**ADDENDUM NO. 1**

**RE: Item #2, May 21, 2025 Letting - P TAPU(36), PCN 08W5, Union County - PCC Shared Use Path**

STATE OF SOUTH DAKOTA	PROJECT	SHEET	TOTAL SHEETS
	P TAPU(36)	28	111

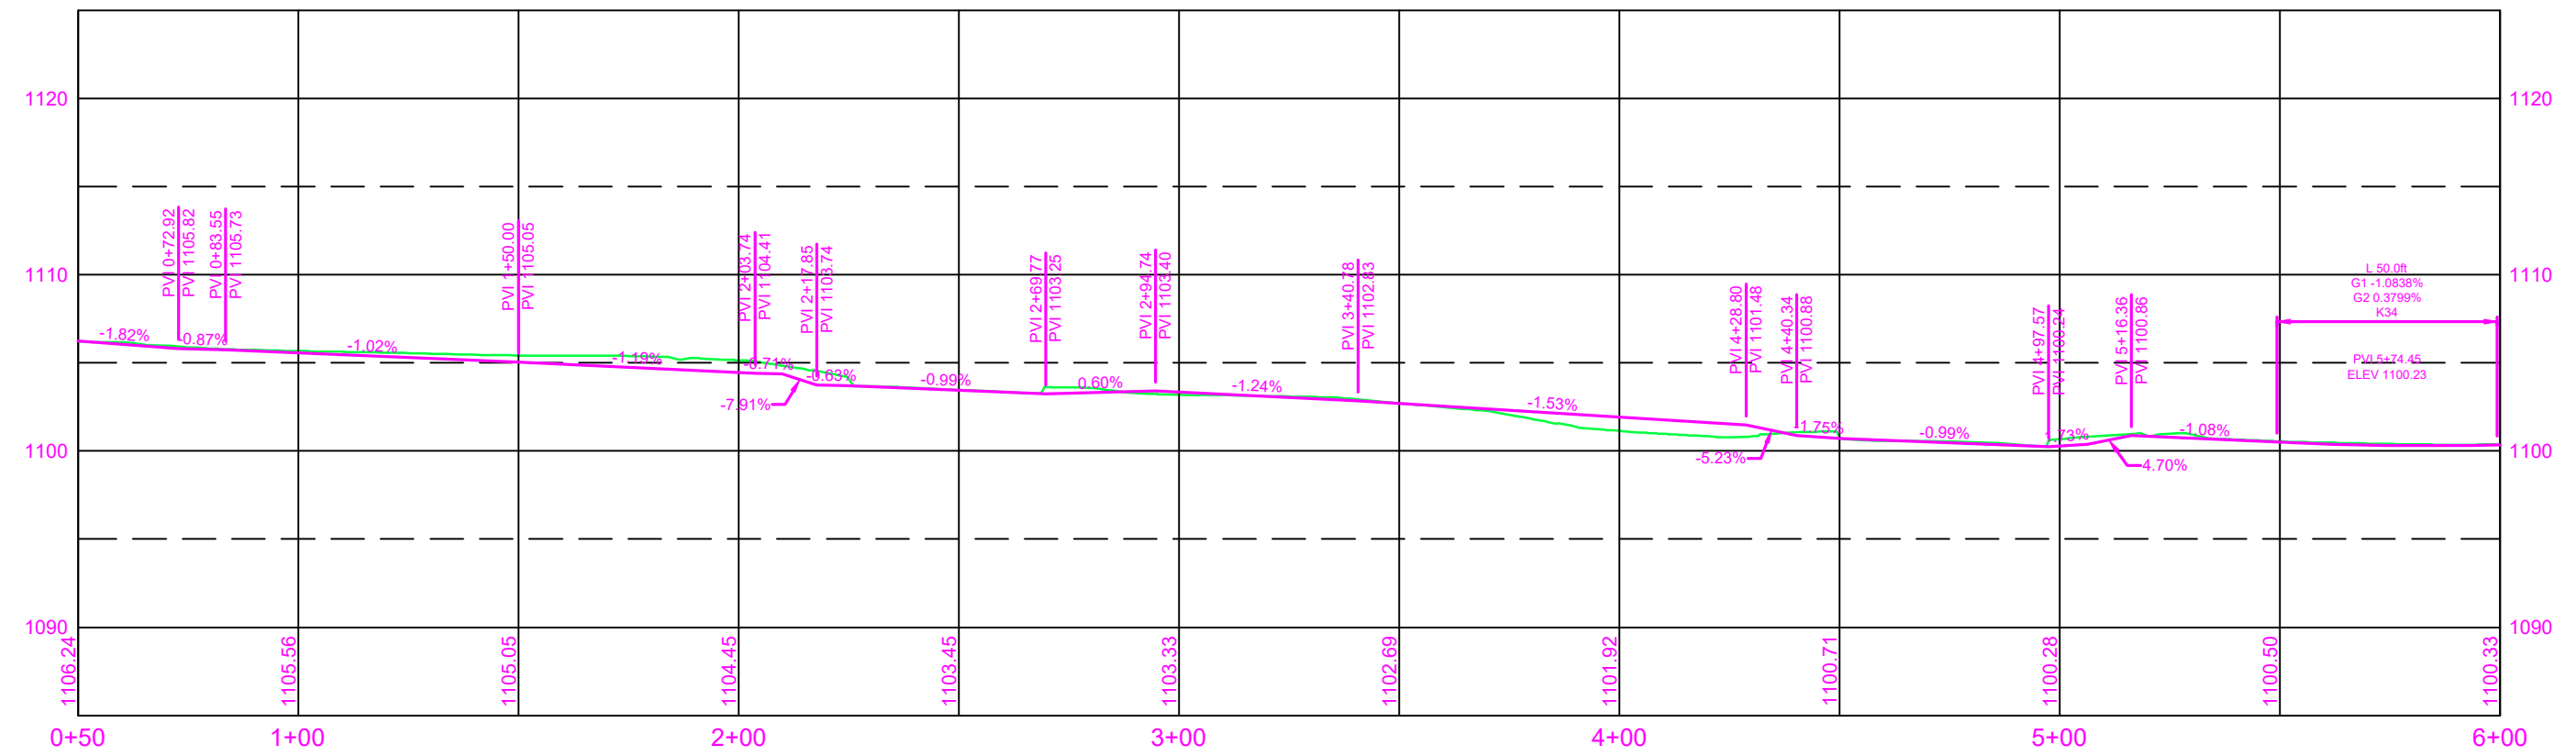
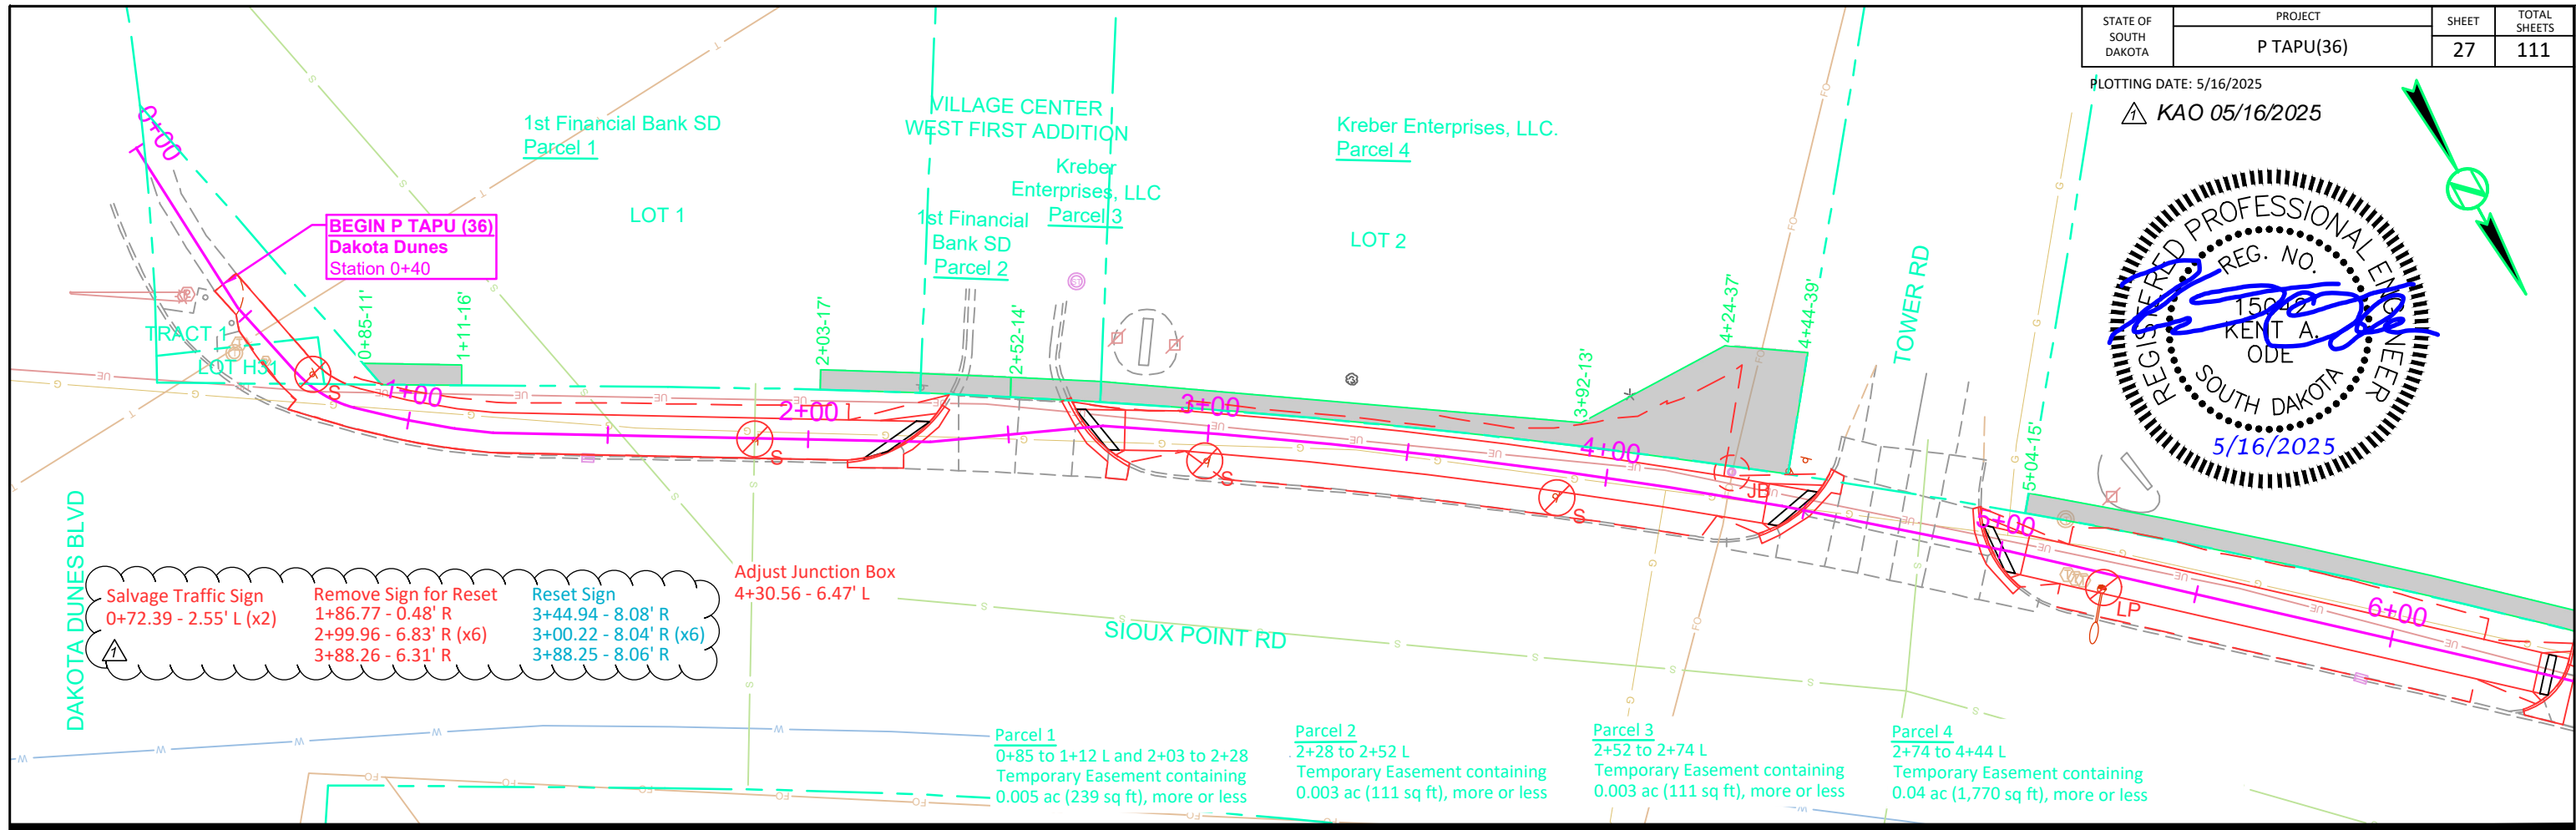
**Sheets 27, 28, 30 & 33:** Sign notes were revised.
